APPENDIX A6

Refinements to project configuration

A6.2 PROPOSED DESALINATION PLANT OUTFALL PIPELINE INSTALLATION METHOD

A6.2.2 PROPOSED REVISION

Figure A6.2 Proposed mine access roads and staggered T intersection

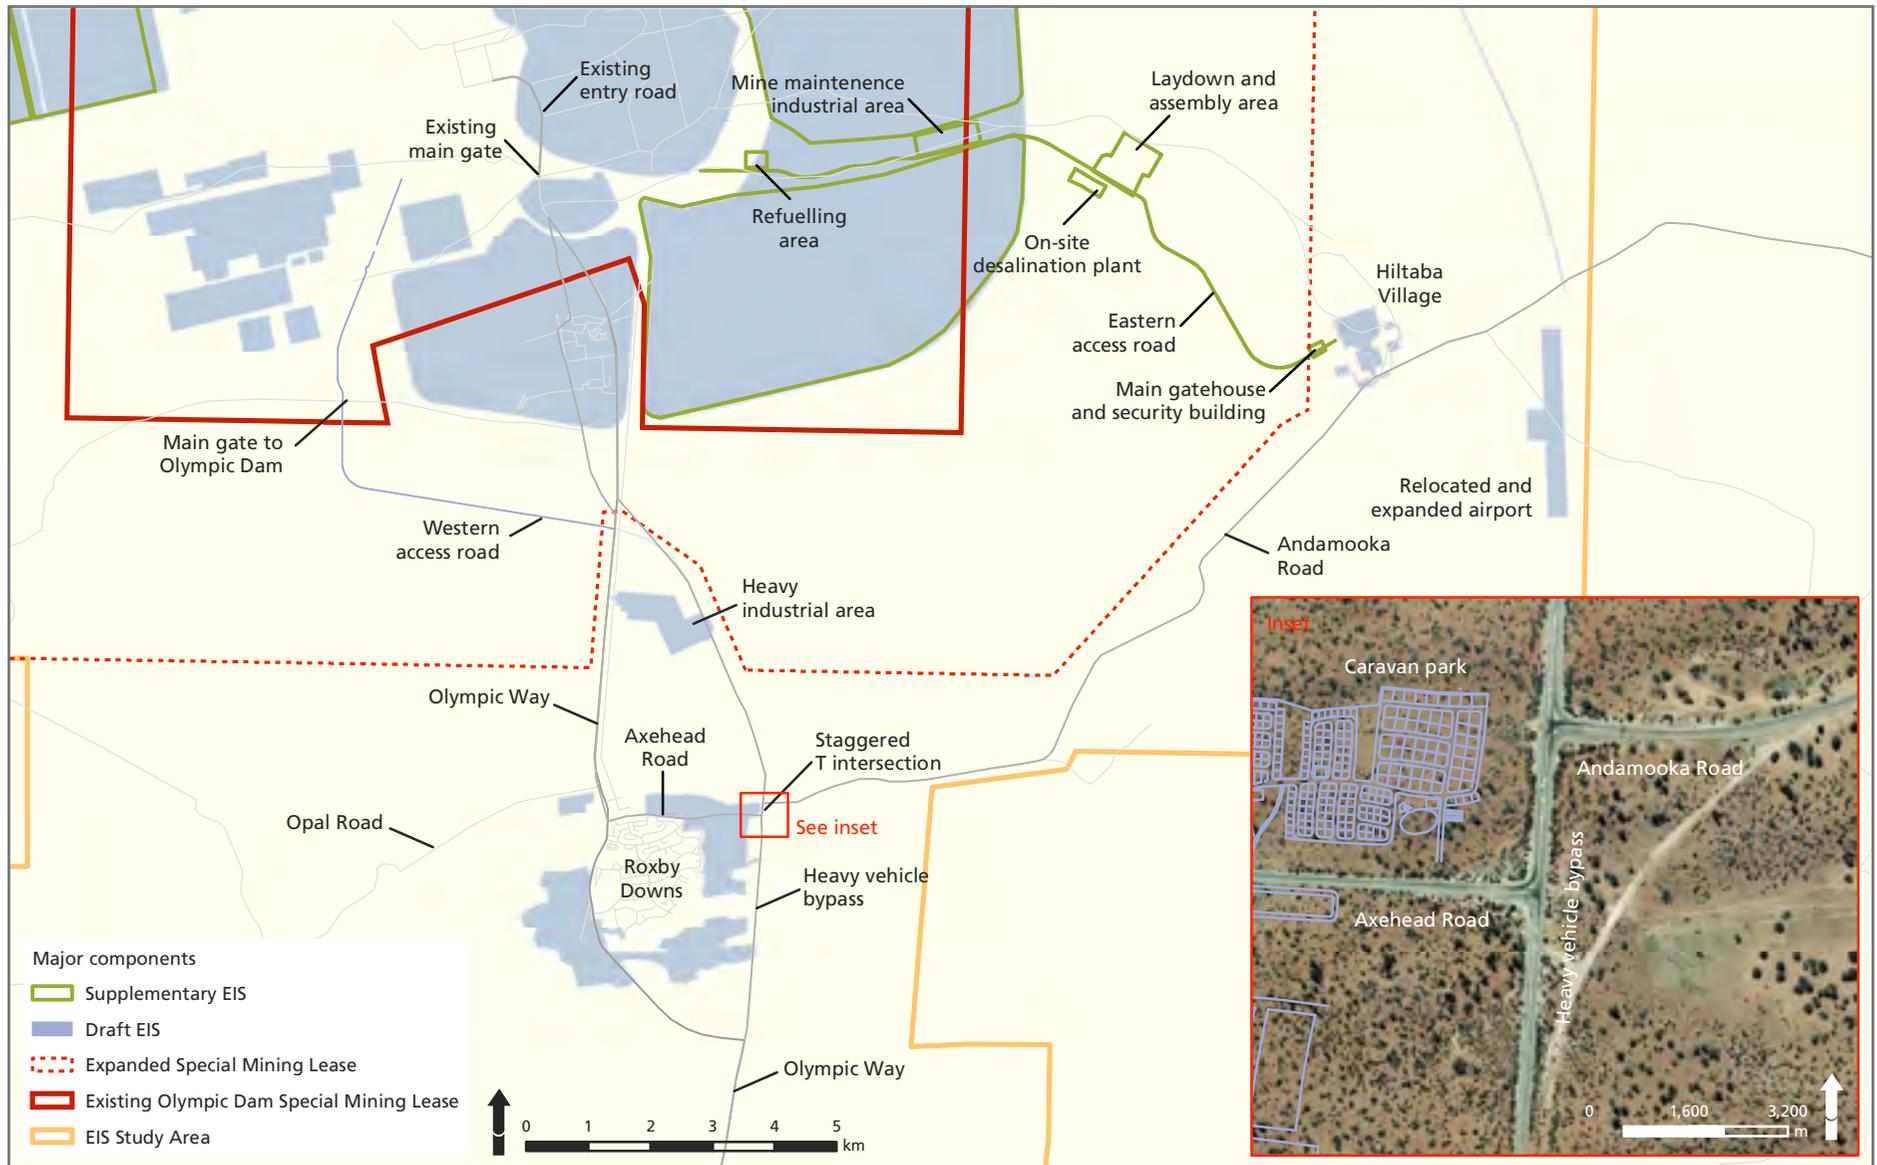
A second entry gate and eastern access road providing a direct link between Hiltaba Village and Olympic Dam is now proposed. Figure A6.2 shows the location of the newly proposed eastern access road, linking Hiltaba Village to the open pit mining area of the expanded operation. This road, together with a second entry gate as shown on Figure A6.2, would provide a second point of access to Olympic Dam. It is proposed that the mining-related workforce is bussed to Olympic Dam along the eastern access road, while the processing-related and administrative workforce is bussed along Andamooka Road and the western access road as described in the Draft EIS.

The implications of this change are an increased traffic flow through the staggered T intersection of Axehead Road – the heavy vehicle bypass – and Andamooka Road. Table A6.2 shows the predicted average annual daily traffic (AADT) for light vehicles and buses through this intersection until a constant traffic flow is reached.

The addition of the eastern access road also creates the opportunity to provide additional on-site facilities, or relocate proposed facilities, to improve access to these facilities and reduce on-site travel times. The relevant facilities are shown in Figure A6.2 and include the on-site desalination plant, an additional mine maintenance area, and an additional laydown area for mining equipment.
